**SUNDRY NOTICES AND REPORTS ON WELLS**  
**Do not use this form for proposals to drill or to re-enter an abandoned well. Use Form 3160-3 (APD) for such proposals.**

8. Well Name and No.  
SKELLY UNIT #950

CHEVRON U.S.A. INC. INTENDS TO RECOMPLETE THE SUBJECT WELL TO THE CEDAR LAKE ABO RESERVOIR.

RE: Recompletion – Conditions of Approval

# Skelly Unit 950 Wellbore Diagram

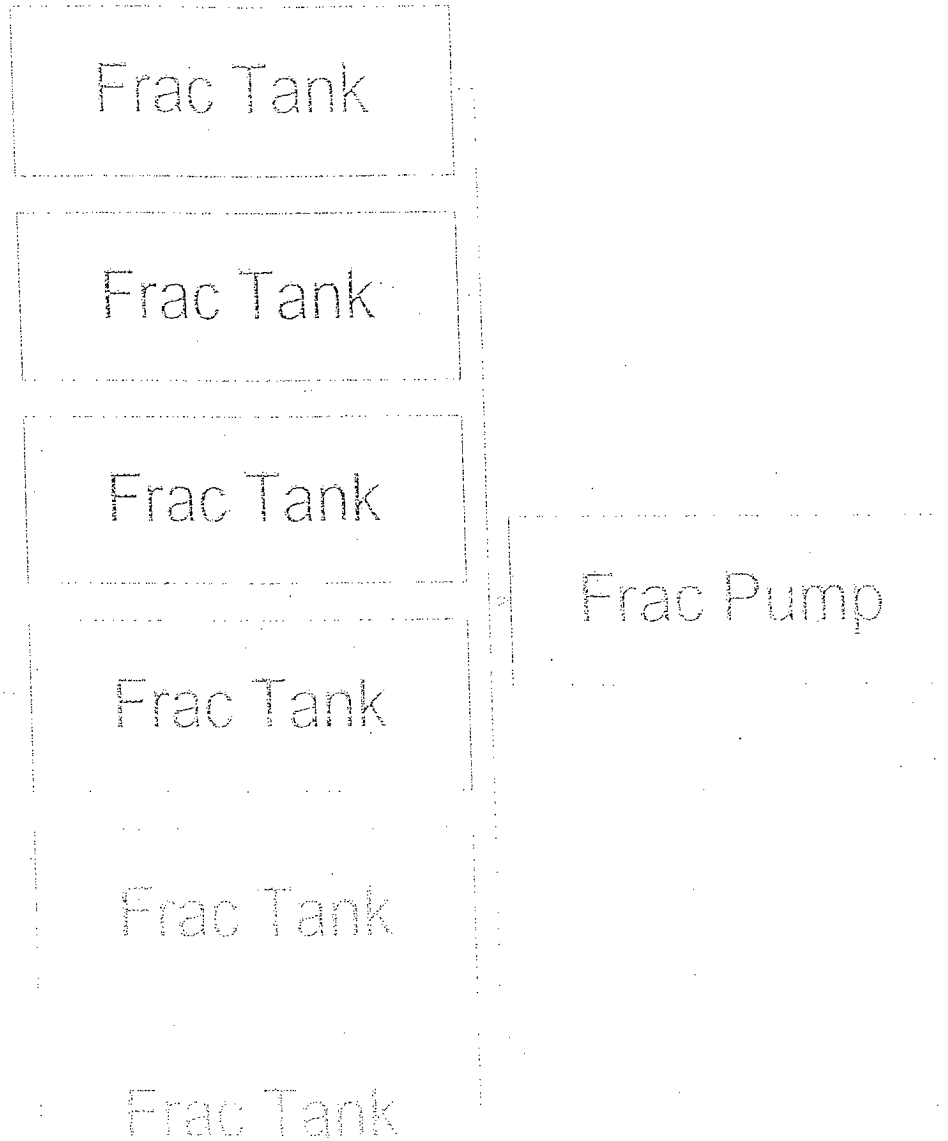
CIBP at 11,300' is not approved. In lieu of proposed plug, spot a 210' Class H cement plug (approx 30sx) from 11450'-11240'. (Morrow)

In addition to proposed plugs, a 190' Class H cement plug (minimum 25sx) is to be spotted from 8675'-8485'. (Wolfcamp)
